Howes Lane, Bicester

Road Safety Audit
Stage 1

23 March 2022

This report describes a Stage 1 Road Safety Audit carried out on a proposed Toucan Crossing on Howes Lane, Bicester.

Figure 2: Proposed Toucan Crossing 'in line' with footways / cycleways.

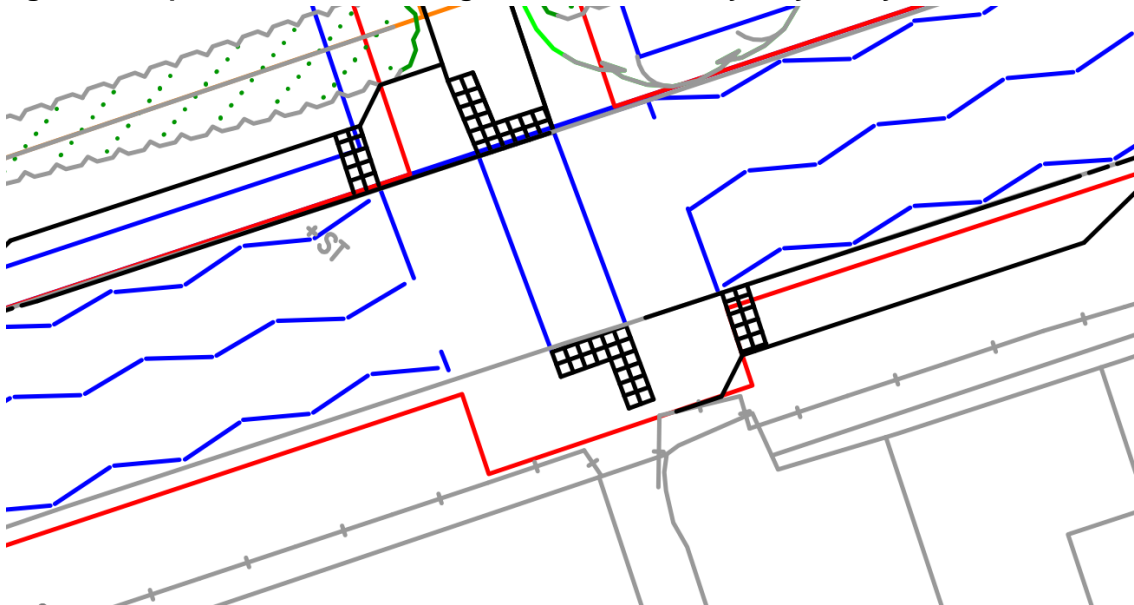
Location: Toucan Crossing on Howes Lane.

Summary: Crossing facility in line with NMU approach may lead to conflicts.

The proposed Toucan Crossing is shown 'in line' with the existing footway link to Wansbeck Drive and the proposed footway / cycleway into the development. As such, pedestrians or cyclists approaching the crossing facility may do so at inappropriate speed increasing the likelihood of NMUs failing to stop before entering the carriageway. This may increase the risk of collisions with approaching vehicles. A guardrail 'chicane' is present at the western end of the existing footway link to Wansbeck Drive to mitigate against this, but a similar arrangement is not proposed on the new footway / cycleway.

It is recommended that either the Toucan Crossing is 'offset' from the footway / cycleway approaches on both sides of the Howes Lane, or a guardrail 'chicane' is installed on the new footway / cycleway on the western side of Howes Lane. The existing 'chicane' on the eastern side should be retained.

B. Location Plan – Howes Lane

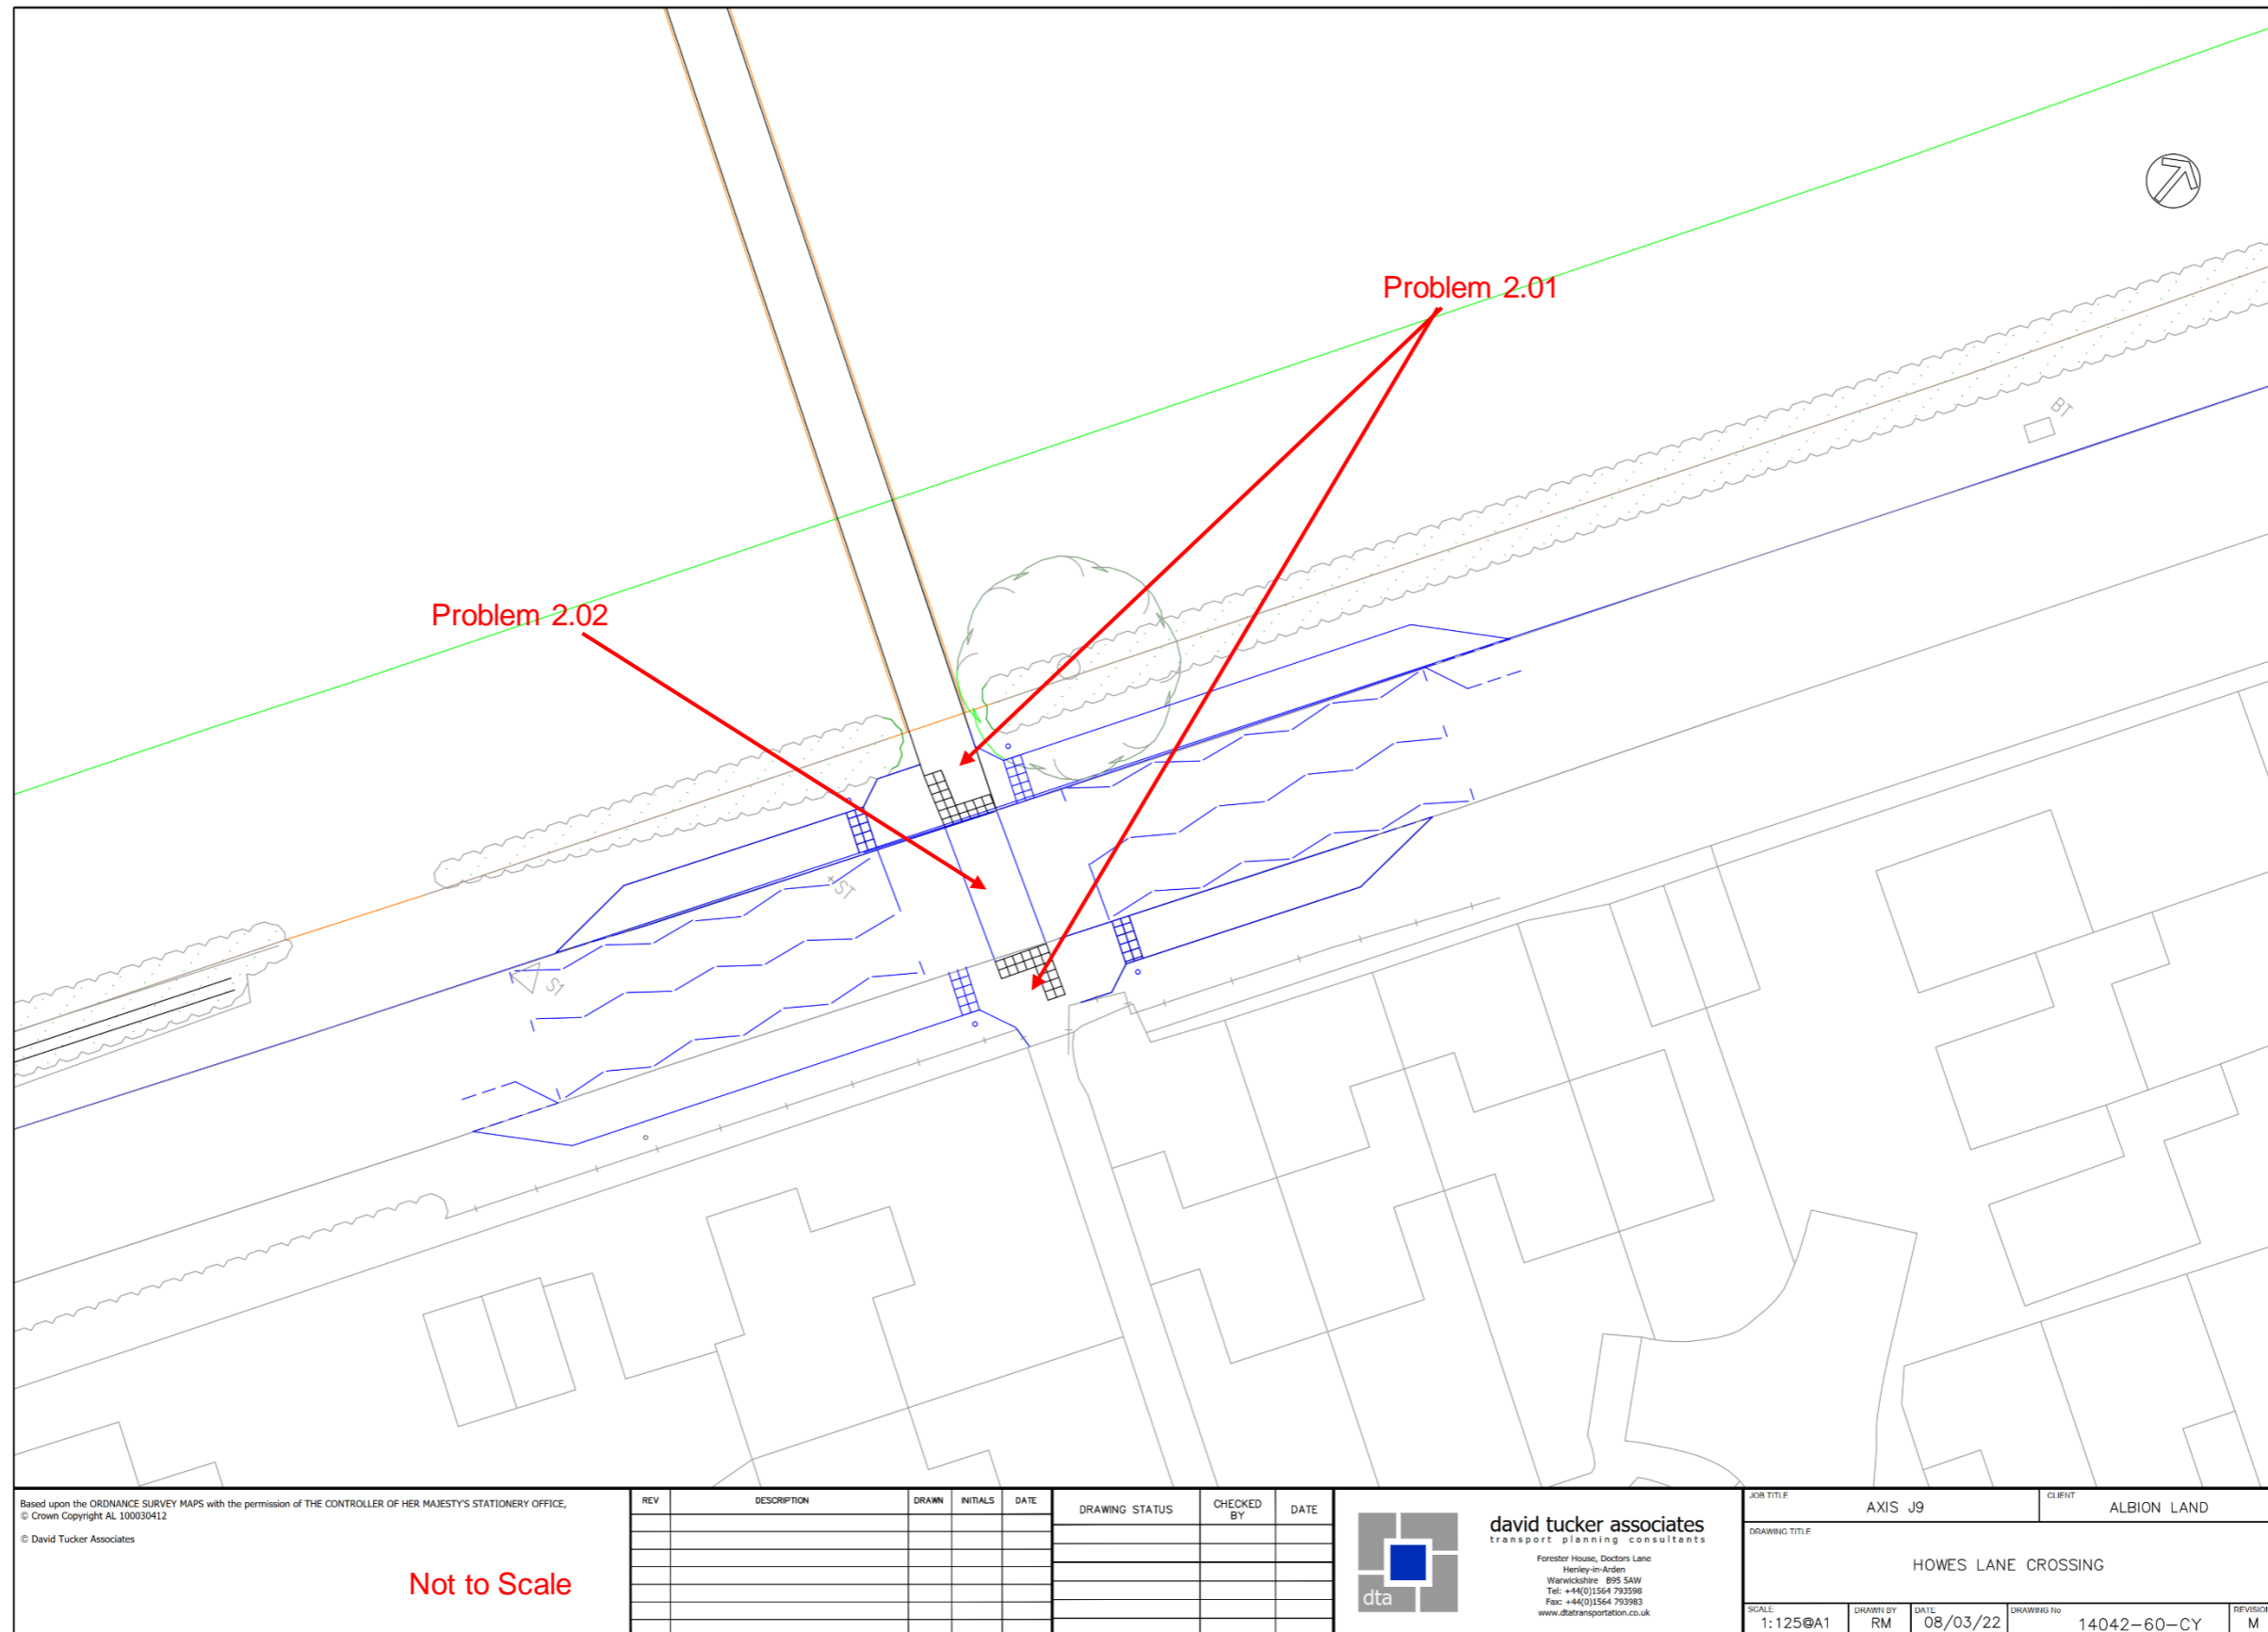
A Key Plan indicating the location of any identified safety related issues is provided in **Appendix B**.
